I refer to planning application [6/2022/2901/MAJ](#). I submitted an objection to The Development on behalf [REDACTED]. I have reviewed the car parking provision for The Development in more detail and wish to raise some concerns.

Part 3. Analysis of TA estimate

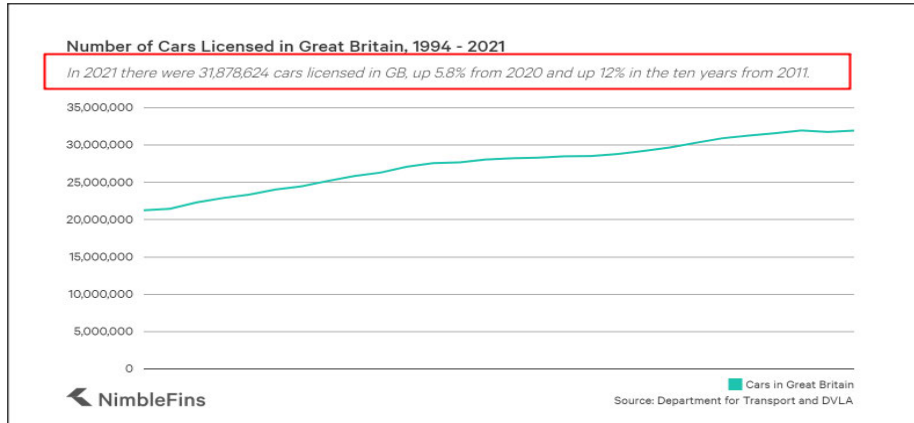
Car ownership has increased year-on-year for decades. Data from DVLA shows that car ownership has increased by 12% between 2011 and 2021 and the trend is upwards.

The TA used figures from the 2011 Census. Using the known growth in car ownership (12%) and the TA methodology shows that the number of spaces needed in 2021 was 188. This is larger than the 183 spaces proposed in November 2022. The demand for spaces will increase about 20 per decade assuming a 10% growth per decade.

By 2040 the demand for parking spaces will be circa 227; this is 44 more than the 183 that is proposed in the TA. This is an increase of 24%. It can be seen the TA has significantly underestimated the need for parking spaces.
